Steel S.S. "EASTERN CLOUD". Rpt. Kob. No. 2767

of the Chief Ship Surveyor are desired on this case for the consideration of the Classing Committee.

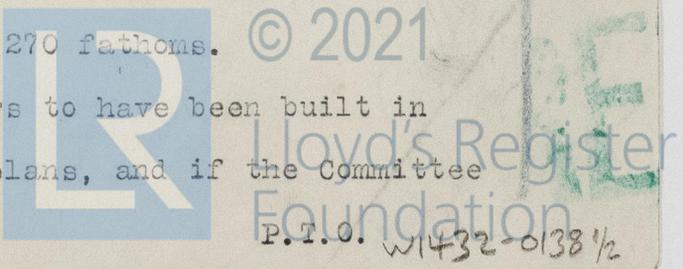
The weight of kedge anchor (incl. stock) is 8. 1. 16. instead s. qrs. lbs.
3. 0. (deficiency 4%), but the collective weight of the anchors excess of that required, and it is submitted the kedge anchor t be accepted.

The chain cables supplied in this case are stated to be 2³/₁₆" ter as required, but the particulars of the statutory and breaking given are those for 2¹/₈" diameter cable, the latter being also the of cable for which chain cable Certificate No. 52696 was issued e Tipton Proving House.

An additional 60 fathoms of cable require to be supplied to the length up to the requirements of Table 31, and it is stated will be done in America.

It is submitted for the consideration of the Committee whether Figure 1 might be assigned, subject to a letter being received from Owners agreeing to accept the chain cables supplied, and also ect to an additional 60 fathoms of cable of correct size being lied to bring the length of cable up to 270 fathoms.
